RE: **7212 Menaul NE**
Grading Plan Stamp Date: 5/28/19
Drainage File: H19D040

Based on the submittal received on 5/29/19, the grading plan cannot be approved until the following corrections are made:

<div>ENGINEER'S SEAL</div> <div>DAVID SOULE NEW MEXICO 14522 REGISTERED PROFESSIONAL ENGINEER</div> <div>5/28/19</div> <div>DAVID SOULE P.E. #14522</div>	7212 MENAUL	DRAWN BY WCUJ
	GRADING AND DRAINAGE PLAN	DATE 5-10-19
	<div></div> <div>Rio Grande Engineering 1606 CENTRAL AVENUE SE SUITE 201 ALBUQUERQUE, NM 87106 (505) 872-0999</div>	2108040--LAYOUT--5-10-19
		SHEET # — JOB # 2109040

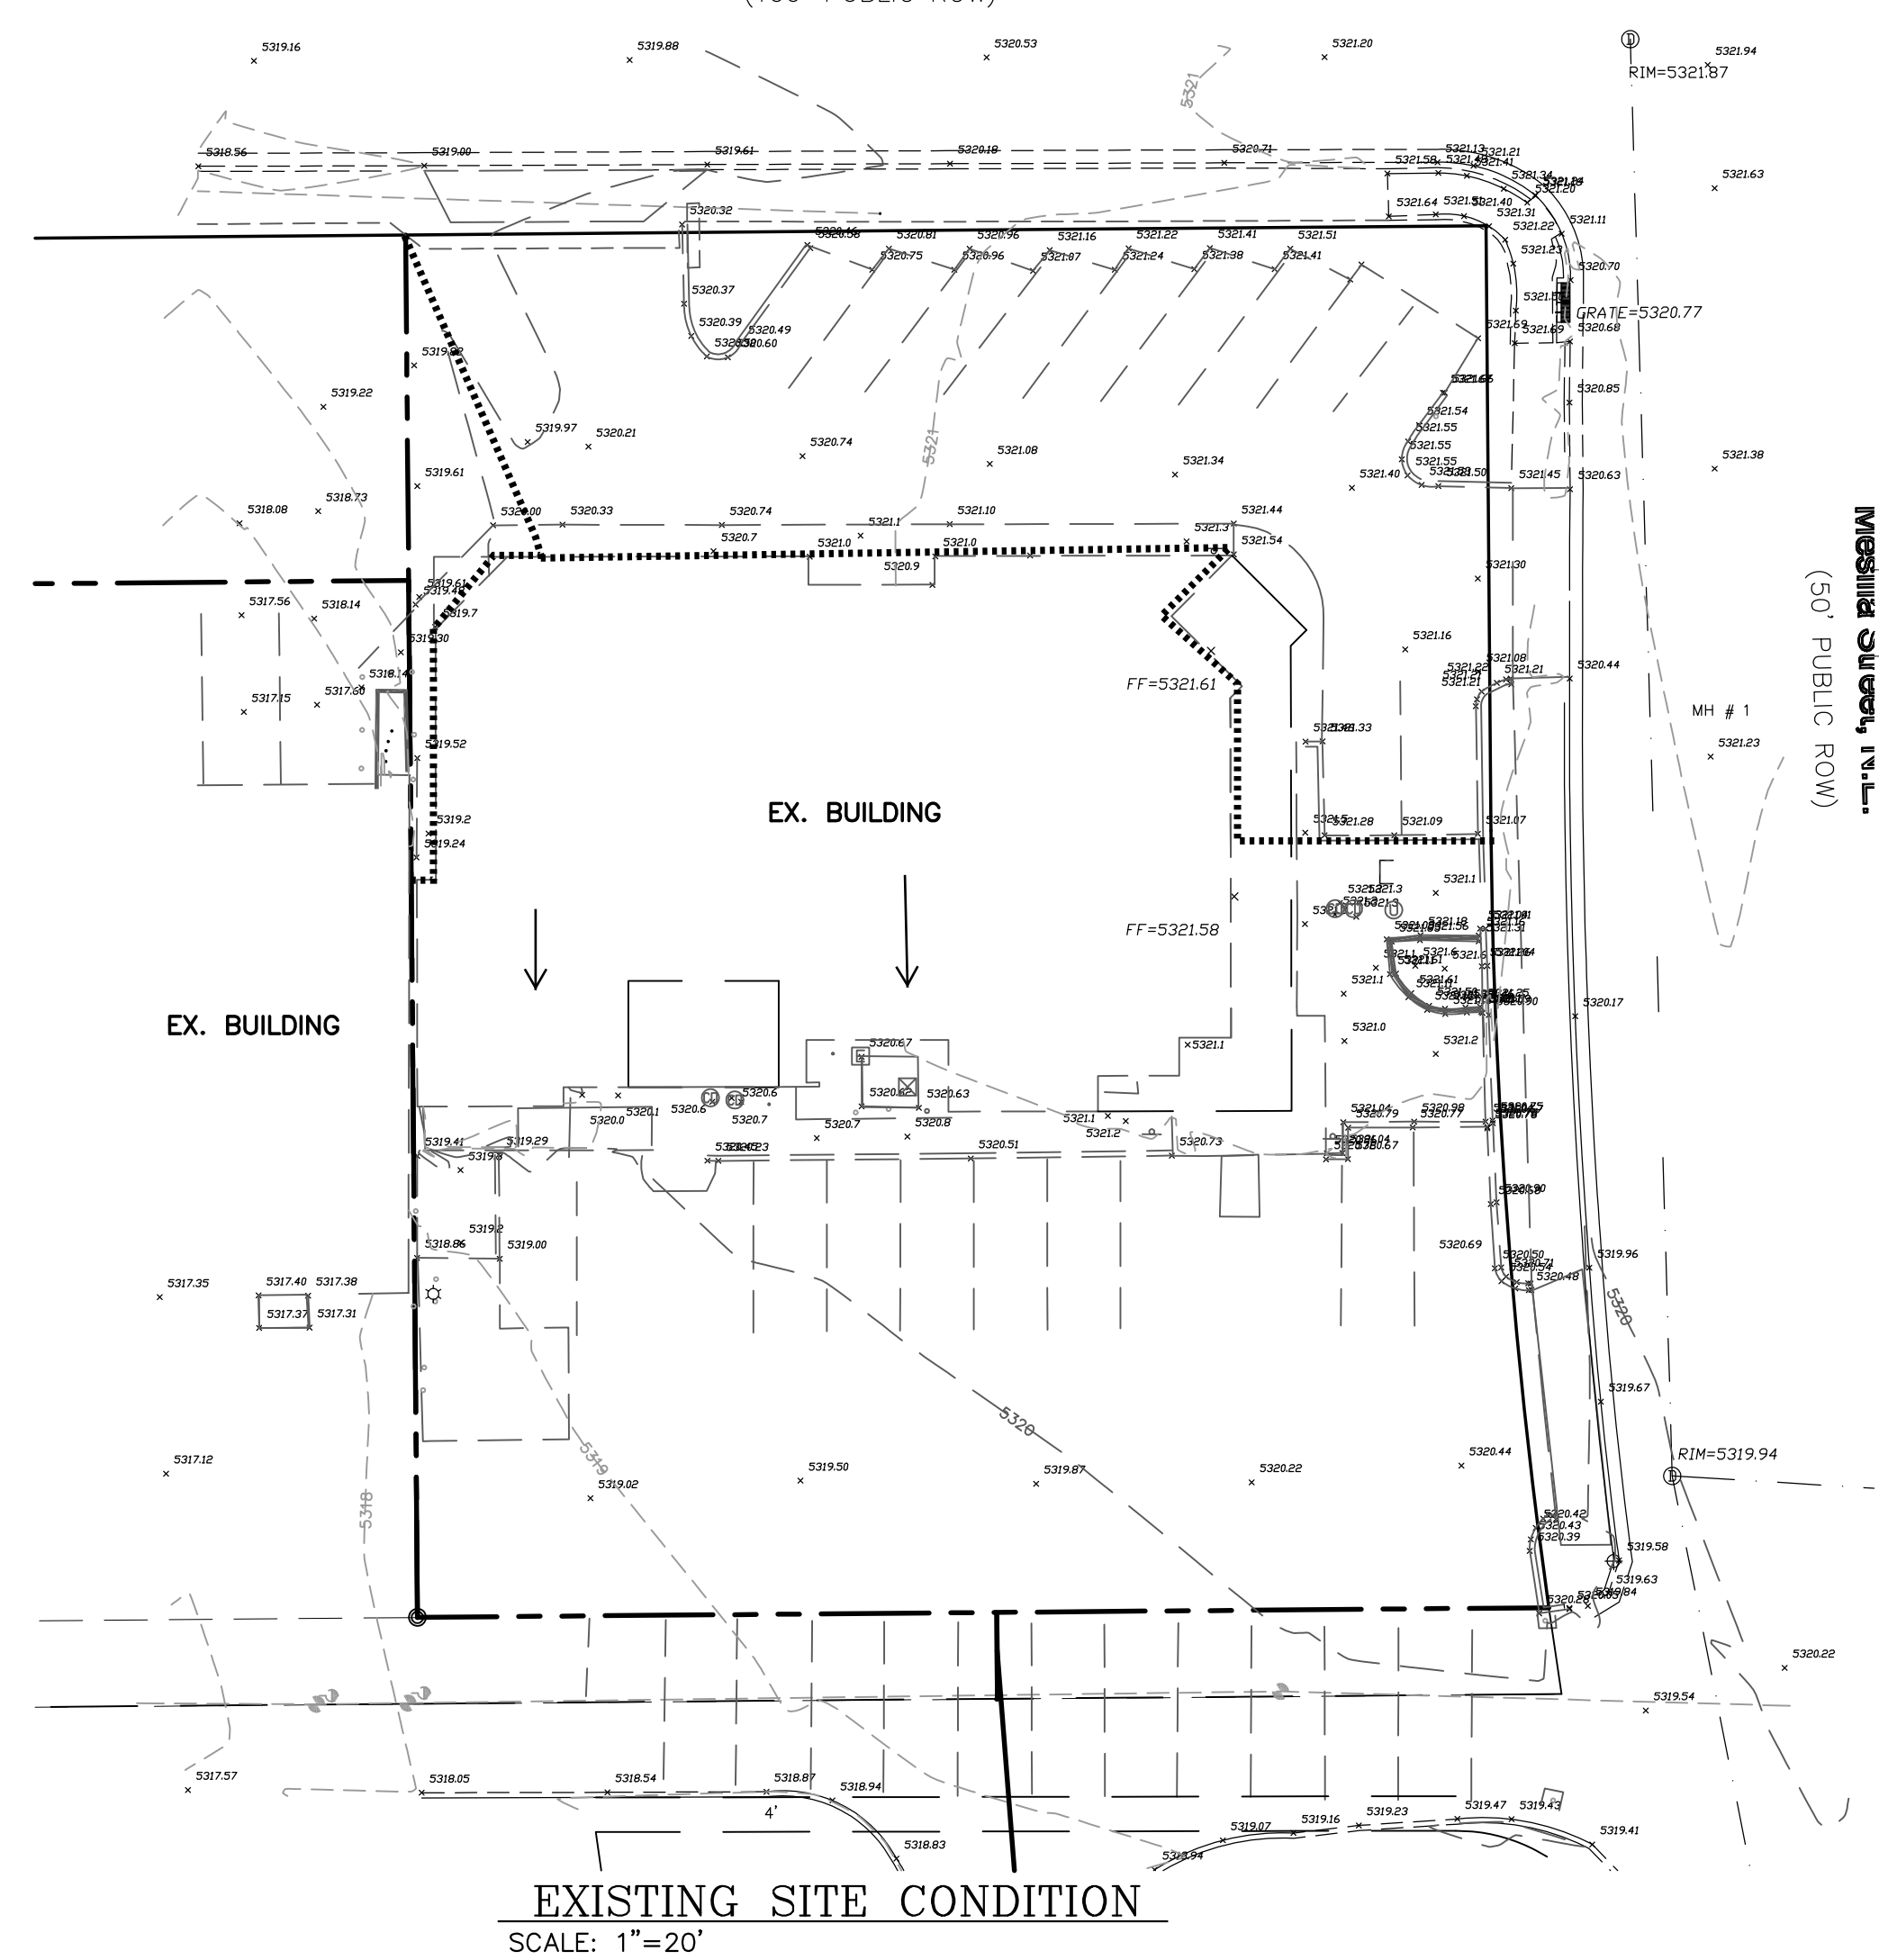
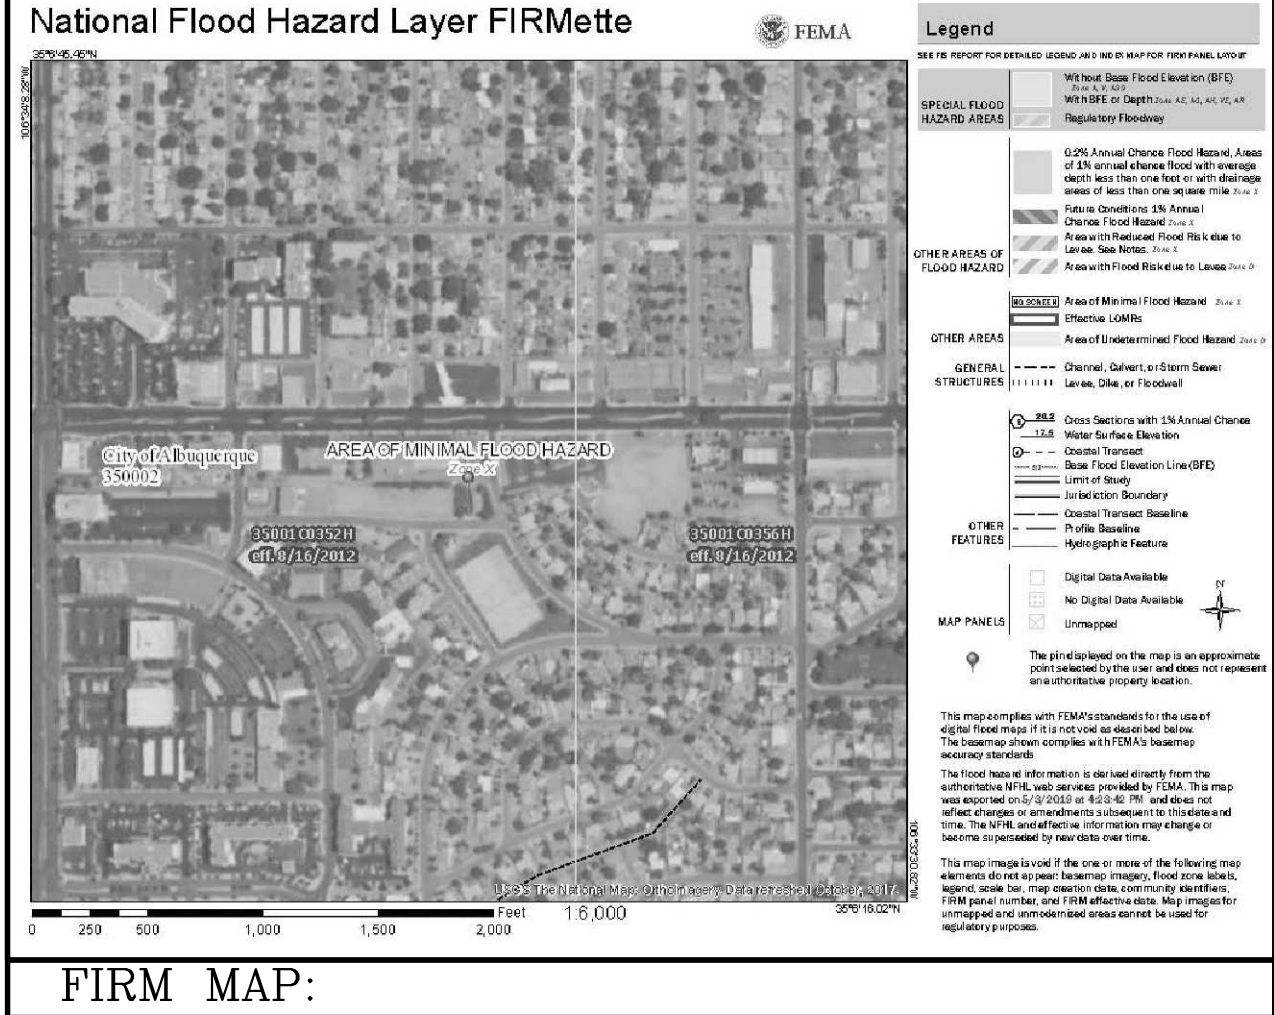
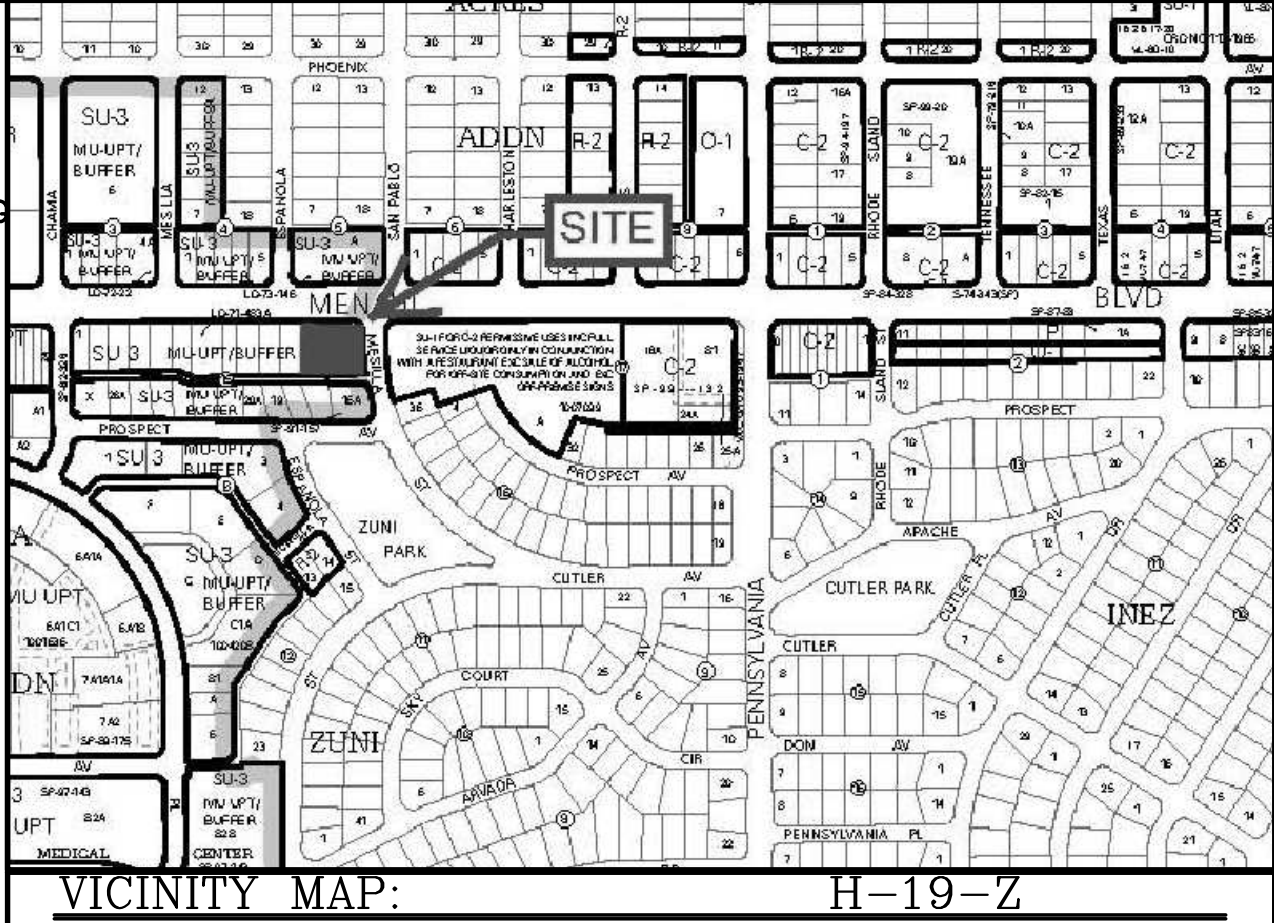
1. Show the grading and site work for repaving the alley.
2. Provide proposed contours and increase the density of existing and proposed spot elevation along the property line. Hydrology is especially interested in the tie-in to the alley and the property to the west.

3. Provide sections through the west property line showing proposed retaining walls, garden walls, property/ROW lines, existing and proposed grades. In accordance with DPM Ch.22, section 5 part B, grading and wall construction near the property line may not endanger adjacent property or constrain its use.

4. The note to end the valley gutter at the Manual entrance also says to begin a retaining wall. Will this cut-off access to the property to the west? Show the retaining wall location.

5. What is the building use? For trash enclosures serving food service developments, demonstrate *control of liquids from dumpster areas* per DPM Chapter 22.9.E, Table 1 by containing runoff from the dumpster area and discharging to the sanitary sewer. If this information is on the utility plan please provide it, or show on the grading plan.

6. Provide a Bernalillo County recorded drainage easement granted by the property owner to the west for discharging across their property, or modify the grading to eliminate cross lot drainage.

7. Payment of the Fee in Lieu (Amount = \$3,149, per the Grading and Drainage Plan) of onsite management of the SWQV must be made. Include a copy of the paid receipt when resubmitting.
